INDESIT company

Model type:
IDC75SUK

Commercial code:
F062940

07427-20 Exploded views

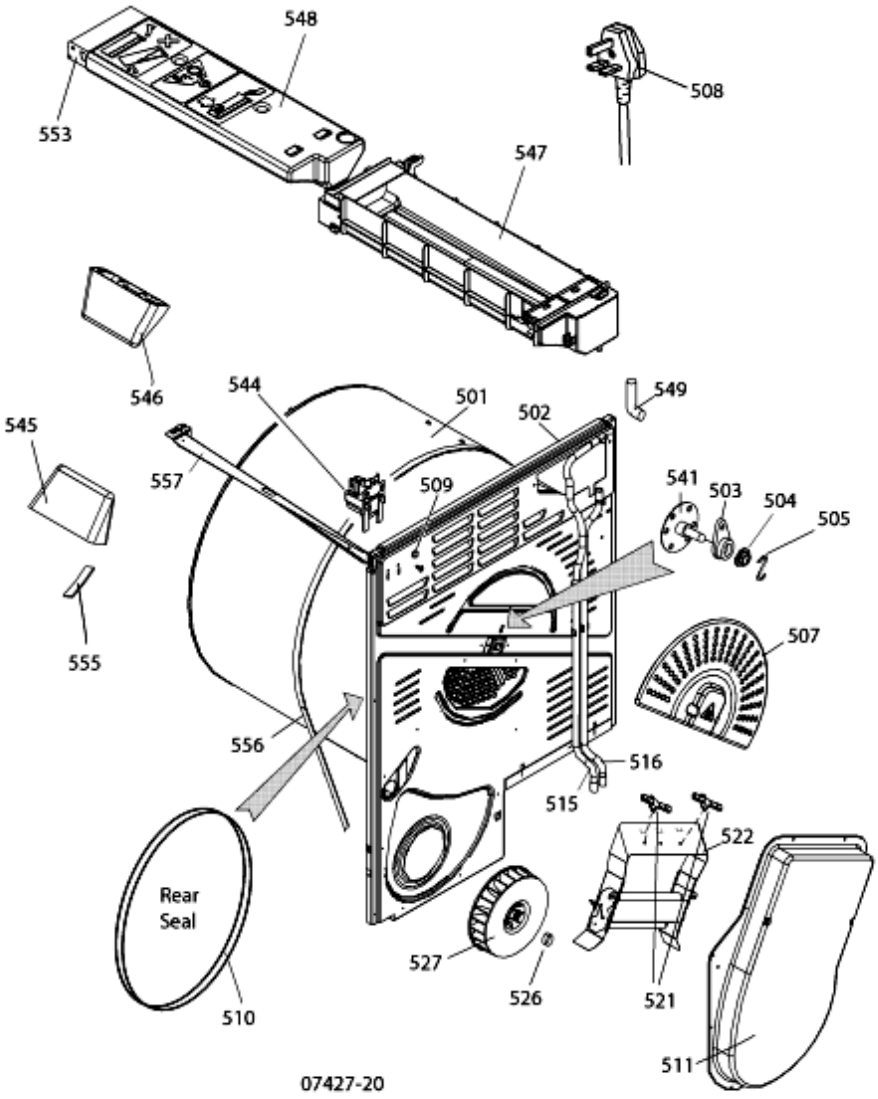
From Serial Number 80901.0001 a new drum with a fixed (Rivetted) shaft has been introduced in production, this drum is interchangeable and will be supplied as the service spare.

Please Note;
There are 2 drum shaft repair kits
Repair Kit for Drums with a Screwed Drum Shaft
Repair Kit for Drums with a Rivetted Drum Shaft
Select the correct kit from the parts list

n4409a00: DRUM SHAFT

Two Drums have been used in production.

Inspect the machine to see which type of drum shaft fixing is fitted.

1 has a drum shaft which is screwed and the shaft only can be replaced if required.

1 has a drum shaft which is fixed and the shaft can not be replaced, if damaged the complete drum assembly will be required.

'C' Energy Condenser Tumble Dryers.
From serial number 90817.0001 the quantity of bearing pads C00255284 fitted on production was reduced fro 5 to 4.

n4410k01: TUMBLE DRYER HEATER CHANGE

FROM SERIAL NUMBER 01112.0000 (12th November 2010) A NEW HEATER WITH A COLOMBO CONNECTOR HAS BEEN USED IN PRODUCTION.
THE ONLY DIFFERENCE BETWEEN THE 2 HEATERS IS THE WIRING CONNECTOR.
IF THE NEW HEATER CONNECTOR IS REPLACED WITH THE CONNECTOR FROM THE ORIGINAL HEATER, THE NEW HEATER CAN BE FITTED TO ALL SERIAL NUMBERS.

n4411j00: PATTERN DRUM INTRODUCED

FROM OCTOBER 2011 A PATTERN DRUM HAS BEEN USED IN PRODUCTION.
THE PATTERN DRUM IS INTERCHANGABLE WITH THE PREVIOUS PLAIN DRUM.
ONCE STOCKS OF THE PLAIN DRUM ARE EXHAUSTED.
THE PATTERN DRUM WILL BE THE SERVICE SPARE.

NOTE
TWO PLAIN DRUMS WERE USED IN PRODUCTION.
THE DRUM SHAFT CAN ONLY BE REPLACED IF THE ORIGINAL DRUM TO SHAFT FIXING IS SCREWED. IF THE DRUM SHAFT IS RIVETED TO THE DRUM, THE COMPLETE DRUM HAS TO BE REPLACED.

n4414g00: DRUM SHAFT REPAIR KITS

THERE ARE 2 TUMBLE DRYER DRUM SHAFT KITS.

C00113038 DRUMS WHERE THE DRUM SHAFT IS SCREWED
C00305794 DRUMS WHERE THE DRUM SHAFT IS RIVETTED.
THE CORRECT KIT MUST ALWAYS BE FITTED.
BOTH KITS CONSIST OF THE DRUM SHAFT/SUPPORT, DRIVE PIN FIXING SCREWS and REAR BEARING.
STARTING FROM JUNE 2014 THE DRUM SEALS WHICH WERE INCLUDED IN KIT C00113038 HAVE BEEN

n4413j00: BREAKING BELTS

To overcome the issue of breaking belts the 6 Rib belt has been replaced by the 8 rib belt C00300793

n4414a03: BEARING PADS REDUCED

FROM JUNE 2013 THE NUMBER OF BEARING PADS FITTED IN PRODUCTION WAS REDUCED FROM 5 to 4.
FROM THIS DATE THE LEFT HAND BEARING PAD (WHEN VIEWED FROM THE FRONT) IS NO LONGER FITTED

07484-05 Exploded views

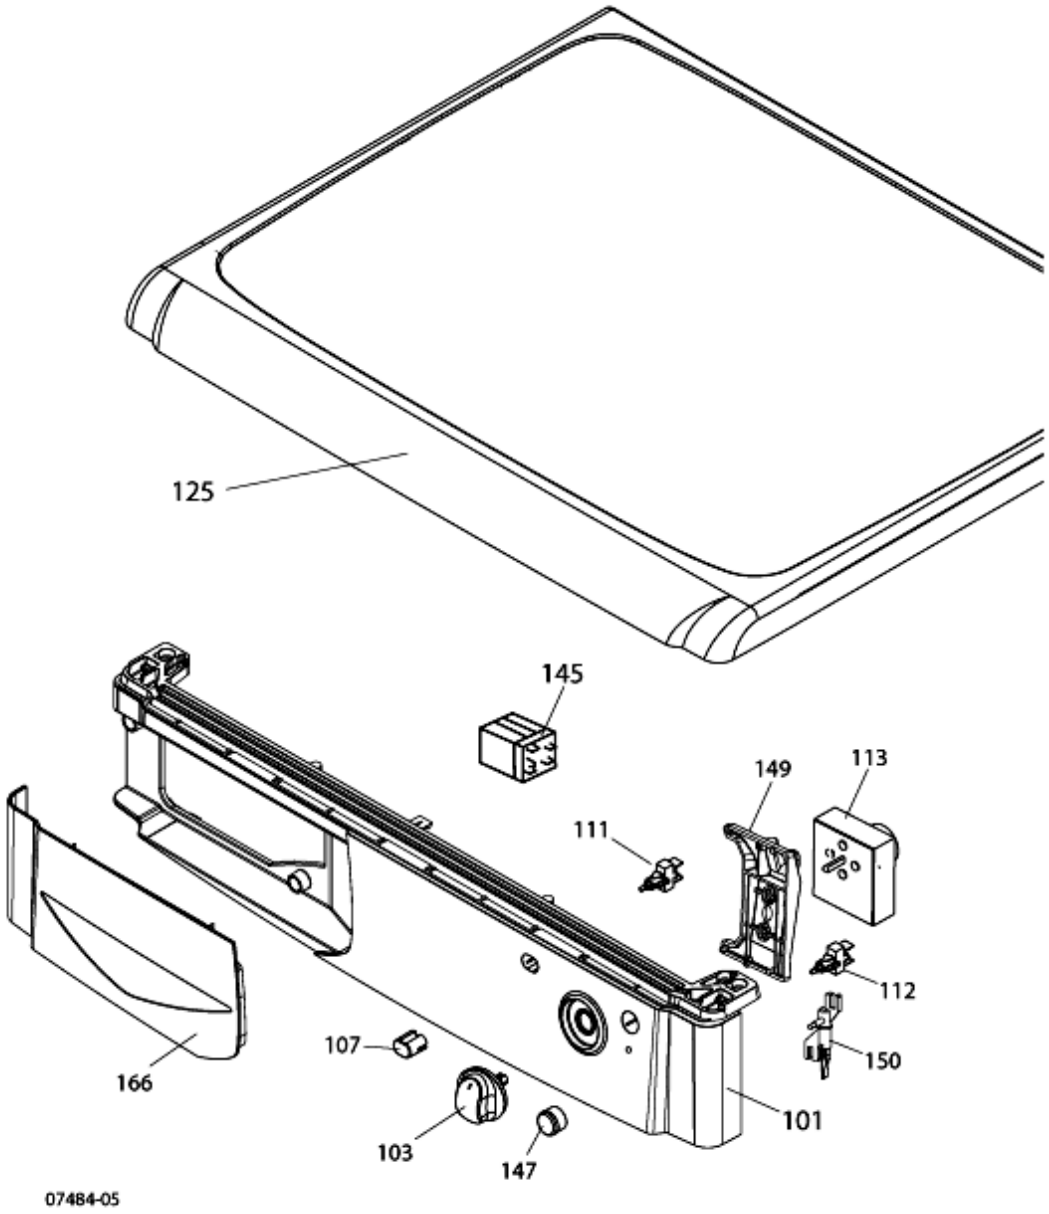
n4411i00: CONDENSER REVERSING TIMERS

2 TIMERS HAVE BEEN USED IN PRODUCTION. INVENSYS AND BITRON (ELBI).
CHECK THE TIMER FITTED TO THE MACHINE BEFORE ORDERING.

THE TIMERS ARE INTERCHANGEABLE, BUT THE TIMER CONECTIONS ARE LABELLED DIFFERENTLY.
THE ALTERNATE WIRING CONNECTIONS ARE SHOWN IN THE WIRING DIAGRAM FOUND IN THE SERVICE MANUAL OR WIRING DIAGRAM.

12721-15 Exploded views

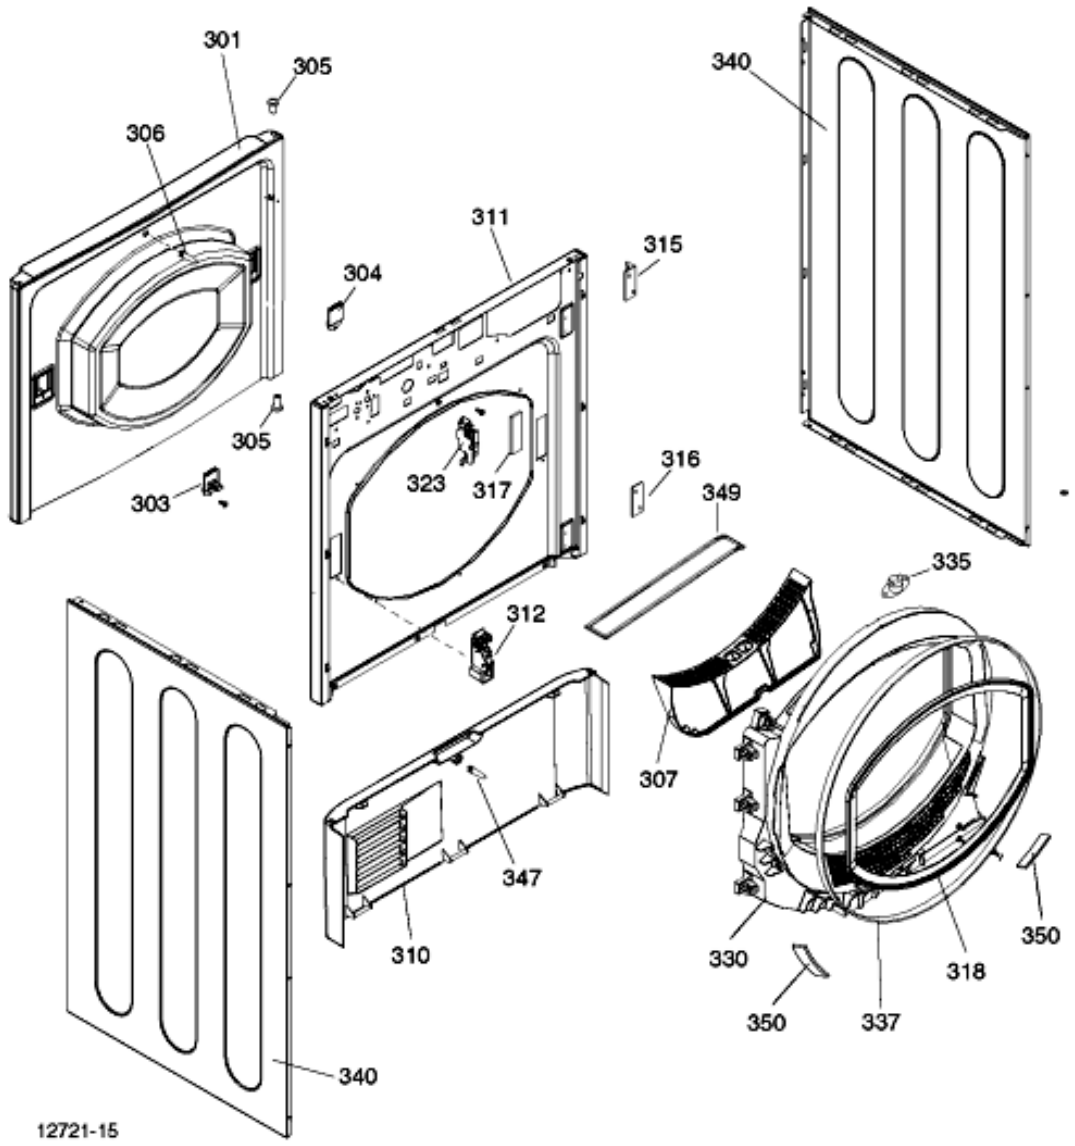
n4411g00: CONDENSER DRYER DOOR SEALS

ON SELECTED TUMBLE DRYERS FROM JUNE 2011 THE DOOR SEAL COLOUR CHANGED FROM GREY TO WHITE.
SELECTED THE CORRECT PART BY DESCRIPTION IN THE PARTS LIST

n4411g07: CONDENSER FRONT AIR DUCT COLOUR CHANGE

FROM JUNE 2011 THE FRONT AIR DUCT FITTED TO CONDENSER TUMBLE DRYERS CHANGED IN PRODUCTION

FROM GREY TO WHITE.
SELECTED THE CORRECT PART BY DESCRIPTION IN THE PARTS LIST

n4414b01: CONDENSER MECHANICAL DRYER FRONT THERMOSTAT

FROM JULY 2013 THE FRONT AIR DUCT THERMOSTAT IS NO LONGER USED IN PRODUCTION>
